Review of the Environment Agency Modelling Associated with the Oxford Flood Alleviation Scheme and the Downstream Reaches of the River Thames from Sandford to Reading Bridge

Review Undertaken for the Vale of White Horse District Council

Version 2: Final Report

Figure 1. The extent of flooding for the baseline (dark blue) and OFAS scenario (cross-hatched)

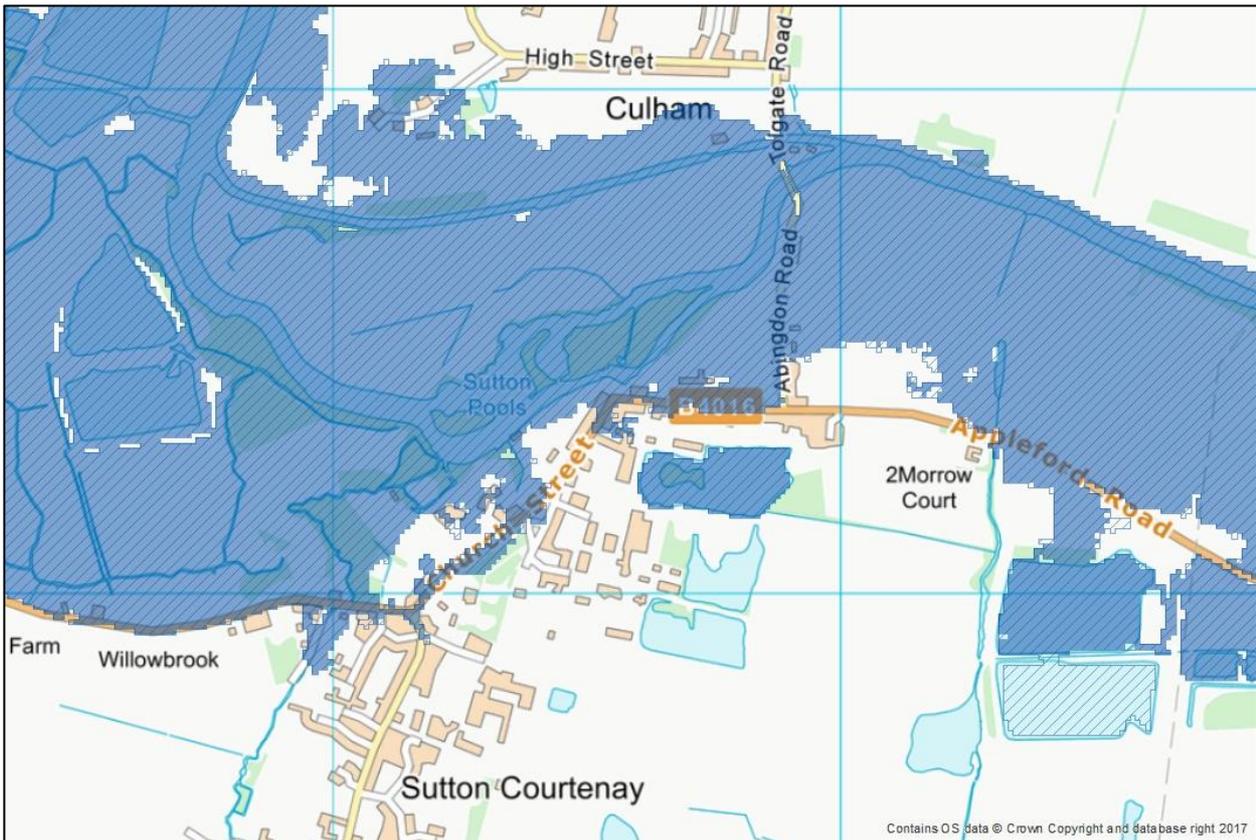
With the increase in water level as given in the technical note, although numerically small, it is not made clear whether property or infrastructure would be affected by any such increases in flood levels. Nothing in the technical note on the impact of these water levels, for example if they are within or above the river banks or a description of the level relative to local ground levels. As part of the demonstration of the mapped flood outlines, particular attention was paid to the areas where an increase in the flood extent was shown to occur with the OFAS scenario when compared to baseline conditions. The slight increases in flood level in the order of 0.01m only led to a very minor increase one area where a larger area was shown to flood was near Sutton Courtenay (Figure 3-1) where according to the CH2M modeller, the slight increase in water level caused the flood water to rise over a threshold into an area of lower altitude land. An examination of the OS base maps found that the flooded area was actually a gravel pit, so the increase in flood extent posed no hazard to any residential areas. in the flooded area in the order of just one or two additional pixels at the 2D model resolution. It should also be noted that the EA has been known to block flood mitigation projects leading to any increases in downstream flood levels, even when it is demonstrable that no property would be affected. Mapping the flood extent at those locations where an increase in water levels has been predicted, either through the application of 1D/2D models or the use of 1D model output and surface interpolation techniques in GIS would be able to demonstrate the potential impact.

The documentation of the downstream modelling study does not attempt to map the flood extents. A separate demonstration of the modelled flood extents has shown very little difference in the flooded extents between the baseline and OFAS scenarios. Where a larger area of inundation was identified in Sutton Courtenay, this was found to be in an existing gravel pit and not a hazard to residential areas.
